## 442 NE Maple Leaf Place

Design Review Recommendation

SDCI Project # 3024493

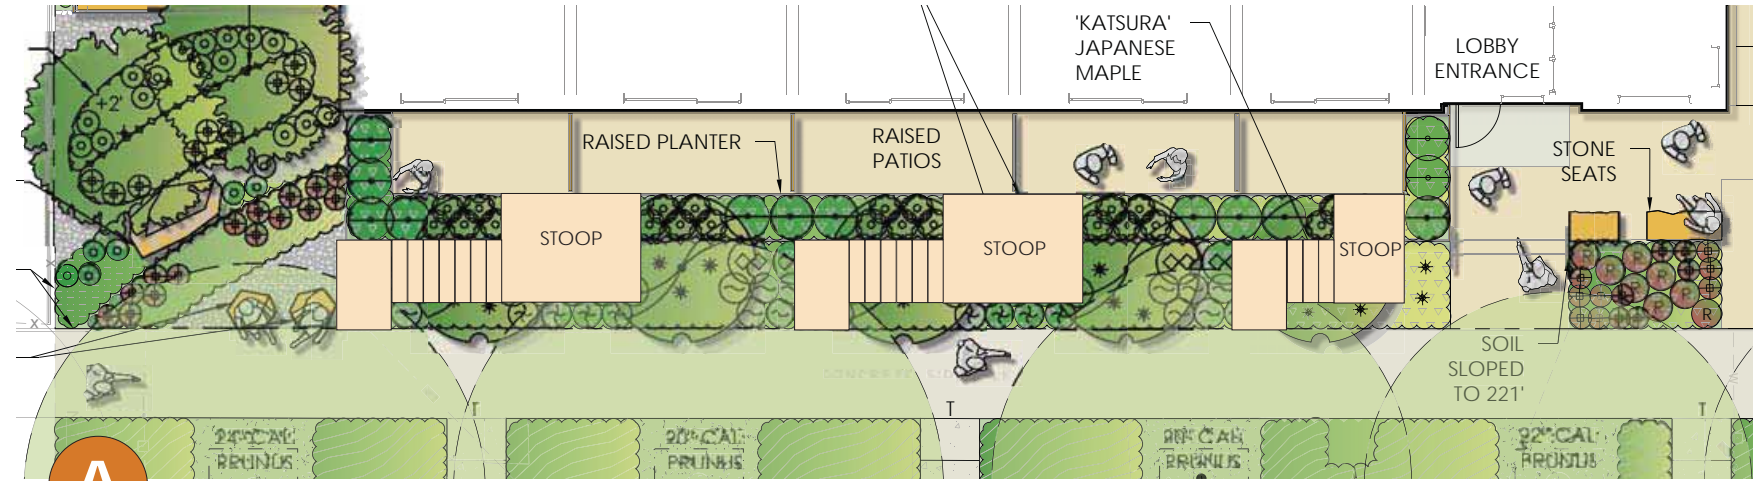
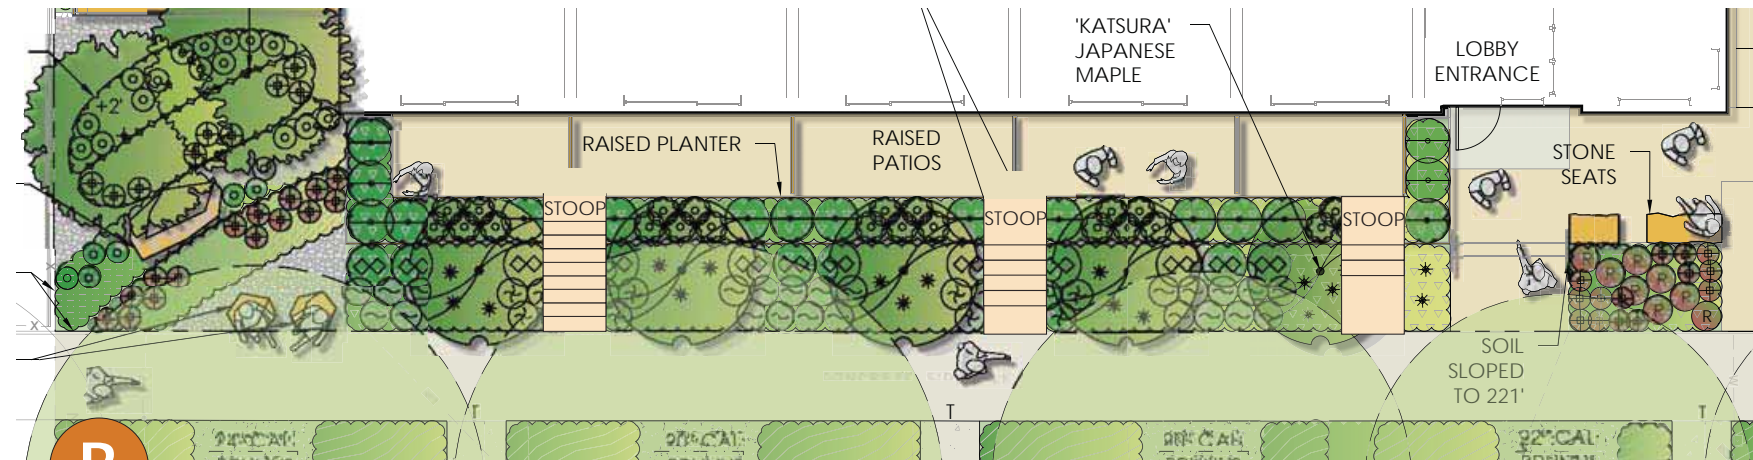
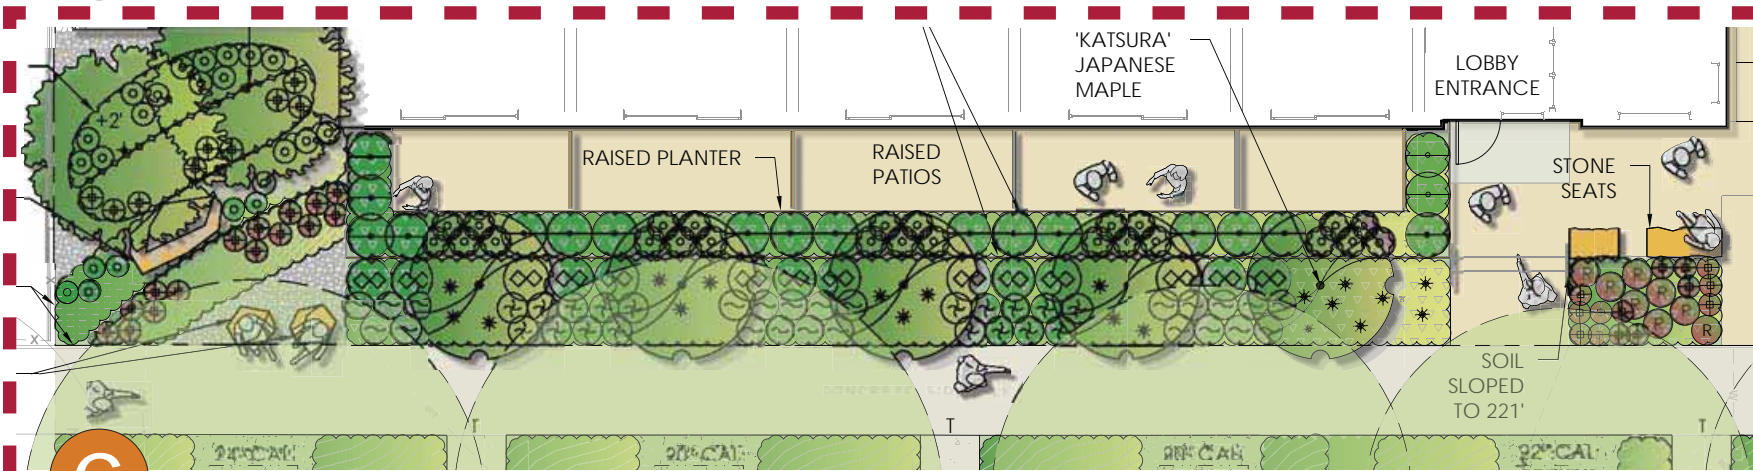
direction: *the Board suggested exploration of “stoops for the ground level units emulating similar stoops used in other structures in the area”*

**response:** several schemes exploring stoops between the sidewalk and ground level units are illustrated. Because the addition of stoops creates competing building entries, raises privacy and security concerns, and reduces the amount of landscaping along the street, stoops were determined to be less desirable than interior-accessed front patios. The proposed preferred design (without the stoops) maximizes landscaping and the perceived width of the front setback, and maximizes safety and privacy for the ground floor residential units along the sidewalk. Note: due to the driveway access from the alley (which already requires a slope departure), the ground floor elevation cannot be lowered nor can the front setback be increased.

- > Departure required: unenclosed steps projecting into setback beyond permitted height and distance
- > Stoop entrances compete with main building entry
- > Compromises privacy, security and safety:
  - \* Patios unlikely to get as much use as preferred option
  - \* Window coverings more likely to be closed than open
  - \* Transition from the street encouraged by code is less effective
- > Landscaping minimized affecting Green Factor
- > Westernmost stoop has 8 risers
- > Less desirable aesthetics with tall stoop wall immediately adjacent to sidewalk
- > Stoops create homeless sleeping area

- > Stoop entrances compete with main building entry
- > Compromises privacy, security and safety:
  - \* Patios unlikely to get as much use as preferred option
  - \* Window coverings more likely to be closed than open
  - \* Transition from the street encouraged by code is less effective
- > Landscaping minimized affecting Green Factor
- > Westernmost stoop has 7 risers, the top two of which cut into the structural deck
- > Stoops create homeless sleeping area

- > Main entrance is more pronounced
- > Natural separation increases privacy, security and safety:
  - \* More active edge with higher use of patios
  - \* Window coverings more likely to be opened than closed
  - \* Transition from the street encouraged by code is more effective
- > Increased landscaping enhances the perceived width of the setback and sidewalk

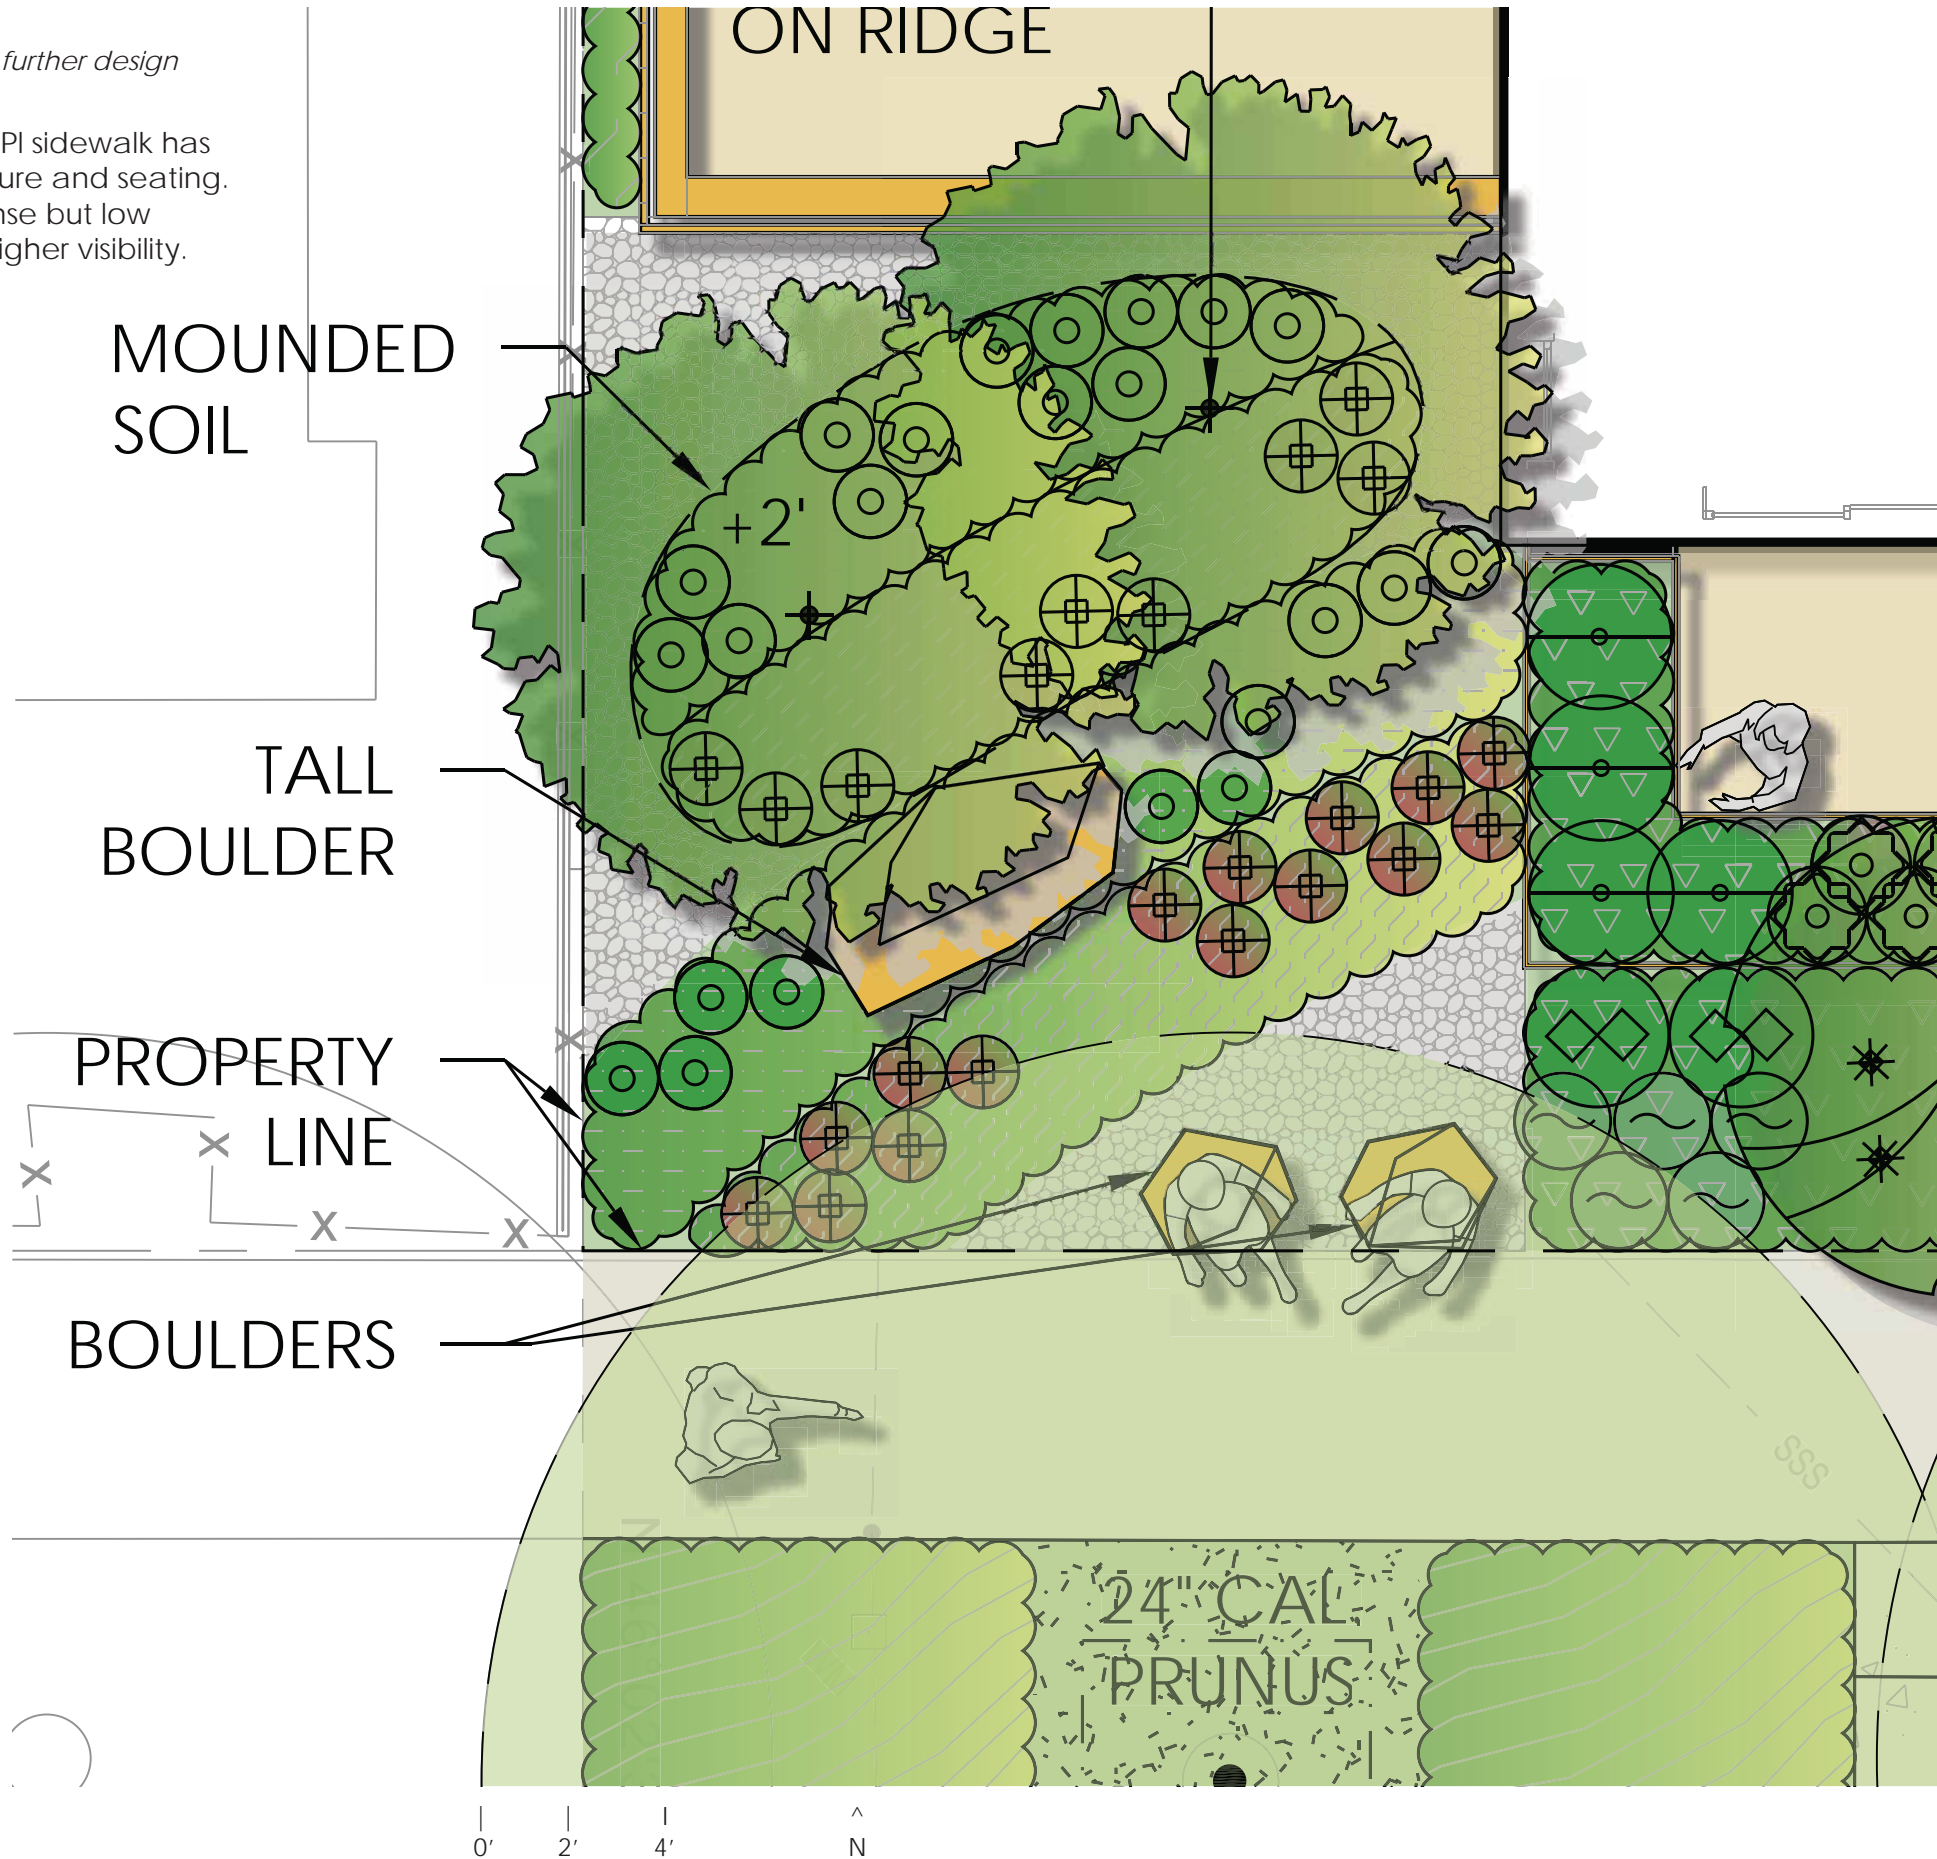
direction: *the Board requested providing "additional landscape detail along with further design exploration at the SW corner of the building along the sidewalk"*

response: the landscape concept at the SW corner along the Maple Leaf PI sidewalk has been further developed to include a landscaped area with a stone sculpture and seating. Addressing safety and security concerns, the area will be planted with dense but low ornamental shrubs and the seating has been located at the sidewalk for higher visibility.

amenity path security ^ diagram

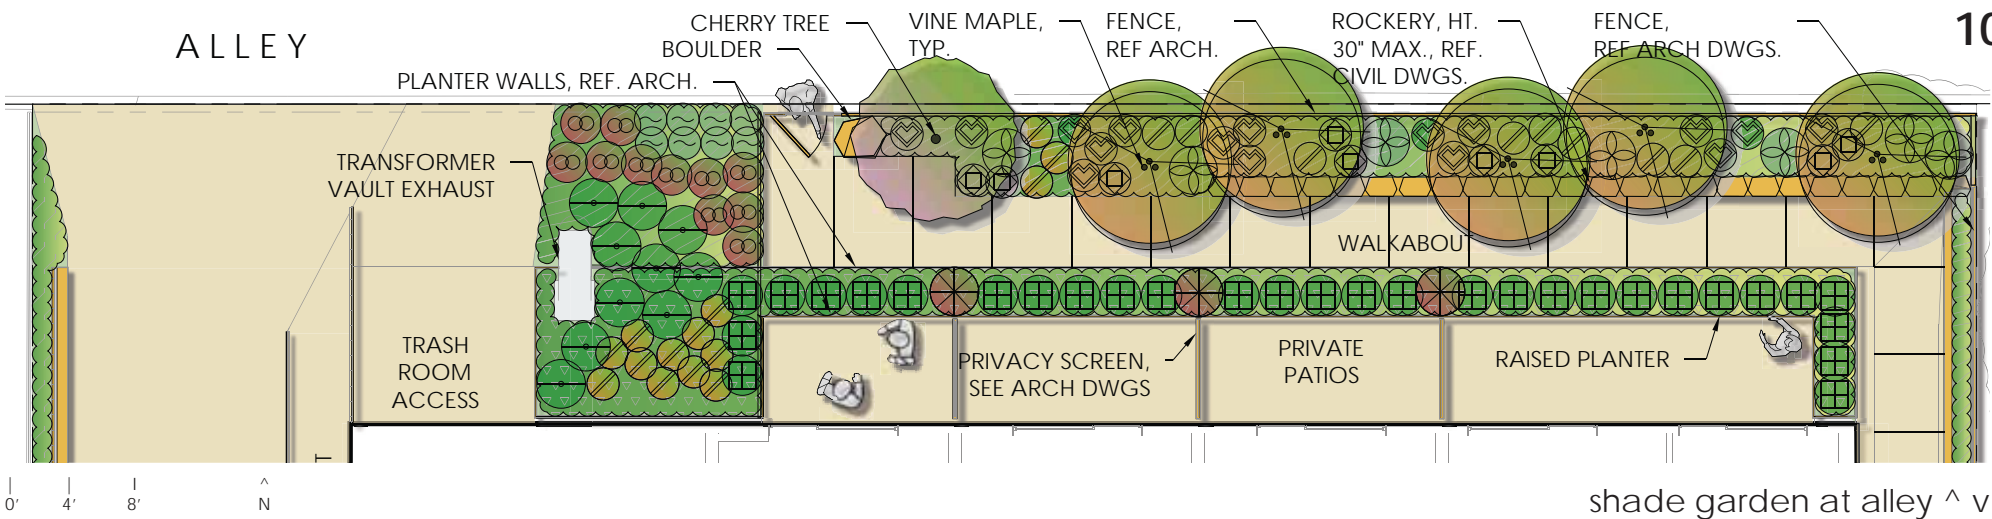
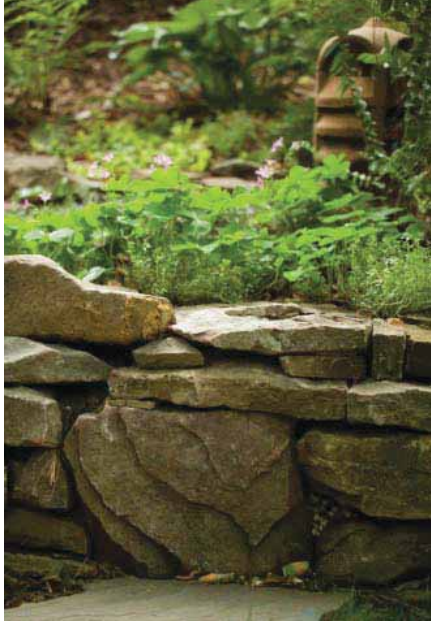
direction: the Board requested that the design team “demonstrate how the walkway along the north side of the building leading from NE Maple Leaf would be secured, closed off to the general public”

response: as diagrammed below, metal security gates have been added at each end of the amenity walkway (at the alley and adjacent to the lobby). These gates are to be locked to non-residents and accessible by building residents and owners only. Additionally, a 6’ high cedar fence has been added along the east property line, and a metal guardrail is shown on the concrete retaining wall to the north of the amenity path at the alley to add privacy and security.

- 6’ high metal gate with wire mesh infill
- 3’-6” high wood fence and gate
- secured concrete amenity path
- 6’ high wood fence
